Technical Advisory - Passenger Loading Sequence for Frog-XT6

The Frog-XT6 user manual does not contain guidance on the passenger loading sequence. Below is the interim guidance. This will be incorporated into the next revision of the Frog-XT6 user manual and training program.

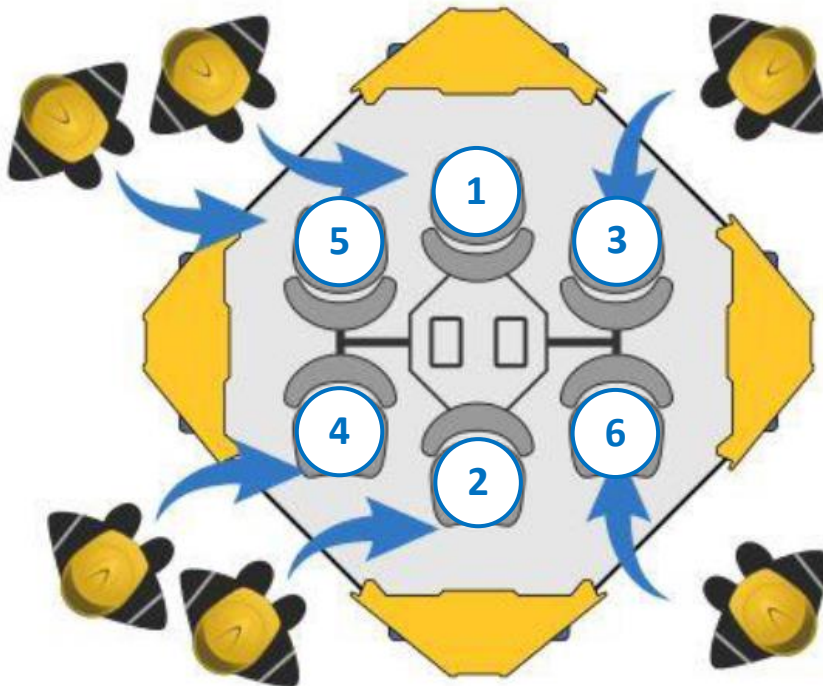
- The first two passengers should use the central seats;
- The second two passengers should be seated to the right-hand-side of the central seats;
- The third two passengers should be seated to the left-hand-side of the central seats.
